DOE/NASA TECHNICAL MEMORANDUM

DOE/NASA TM-78163

OWENS-ILLINOIS LIQUID SOLAR COLLECTOR
MATERIALS ASSESSMENT

By R. L. Nichols
Materials and Processes Laboratory

Figure 5. Copper tube socket.

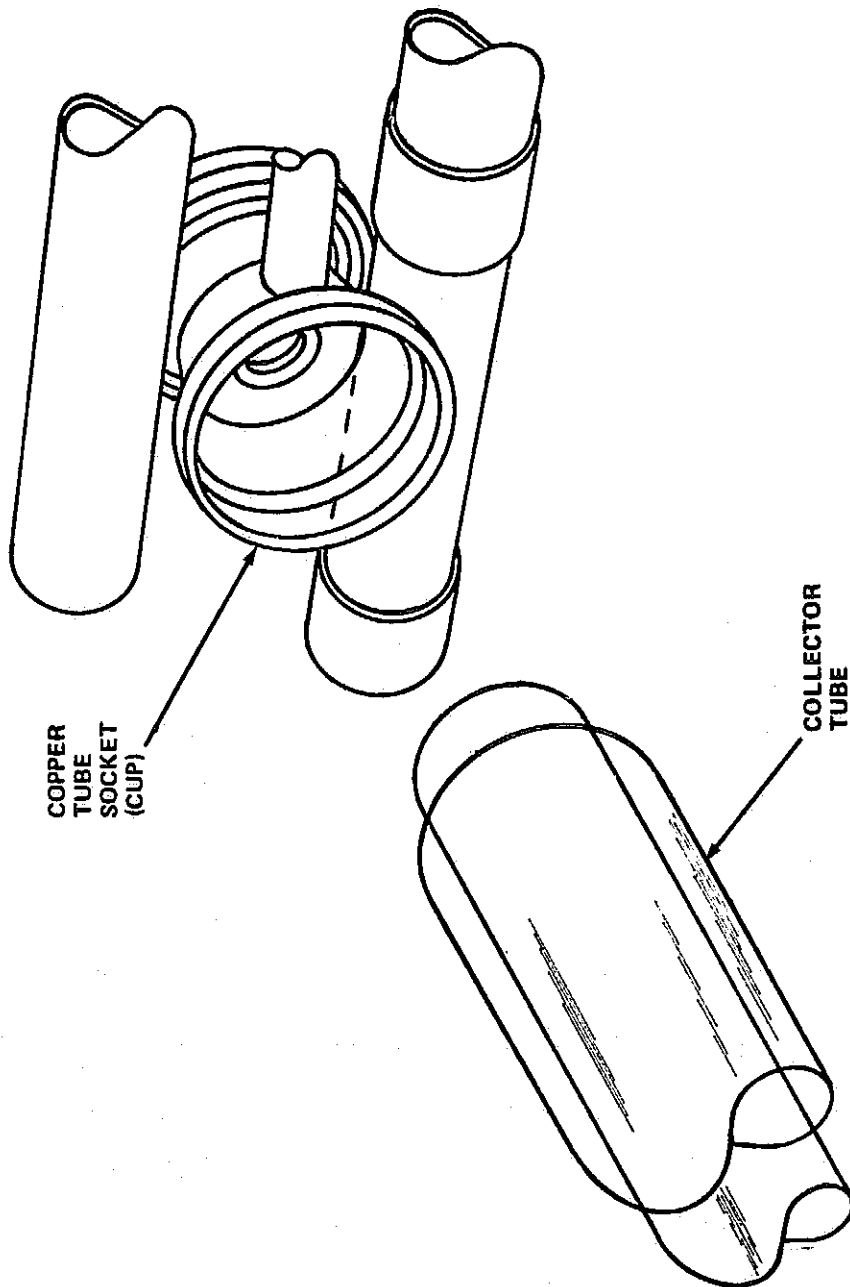
The liquid flow in the collector is channeled from one tube pair to the next by copper tubing and cups shown in Figure 5. These individual components are soldered together with Welco No. 5 solder (95 percent tin, 5 percent silver) which melts at approximately 435°F (224°C). The maximum temperature observed near a soldered component during boilout and stagnation on the solar simulator was 495°F (257°C) at the cups.

Soldering does not appear to be an adequate process for fabricating the cup assemblies. The flow of the solder, due to gravitational force, does not fill the joint as desired; the surface area in the joint is relatively small for a soldered assembly carrying loads; and the melting point of the solder is too low for the temperatures observed in stagnation/boilout.

Two alternatives are potential solutions to these problems. O-I could utilize a fully cast precision manifold where no soldered joints are necessary, or they could redesign the manifold and braze the components together. The present design does not lend itself to brazing because of the high probability of distortion due to creep and thermal expansion differences in the cups and tubing.

The solder used to assemble the manifold softens at a temperature very close to those observed during boilout conditions. The components should be brazed together provided the copper is not fully annealed during the process. The optimum manifold system would be one which is a monolithic casting. This would eliminate seal leakage and improve the tolerance achievable on the manifold.

Figure 6. Tube support cup insert.

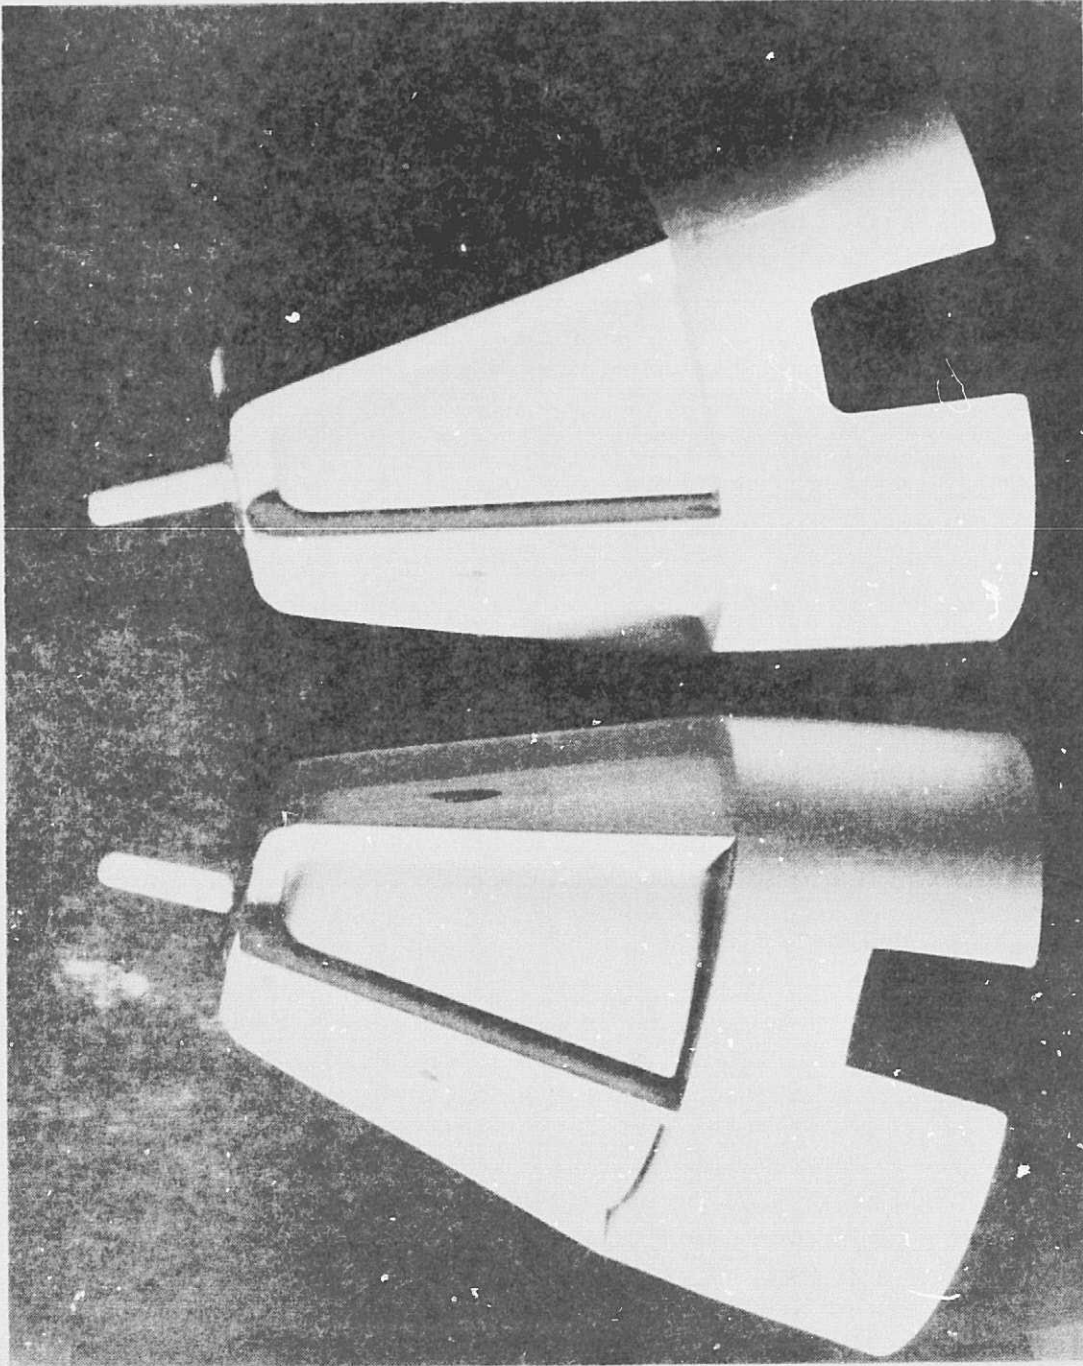
The tube support cup insert (Fig. 6) is the only plastic component identified as a potential problem area. A maximum temperature of 205°F (96°C) was observed at the position of this part. The problem encountered is deformation of the cup insert due to thermal softening during the boilout mode of collector operation. This component could be redesigned to a conical shape to improve distribution of the load transferred to it from the collector tube's closed end. Fabricating this part from a higher temperature material than acrylic-butadiene-styrene (such as polycarbonate or polysulfone) should alleviate this problem.
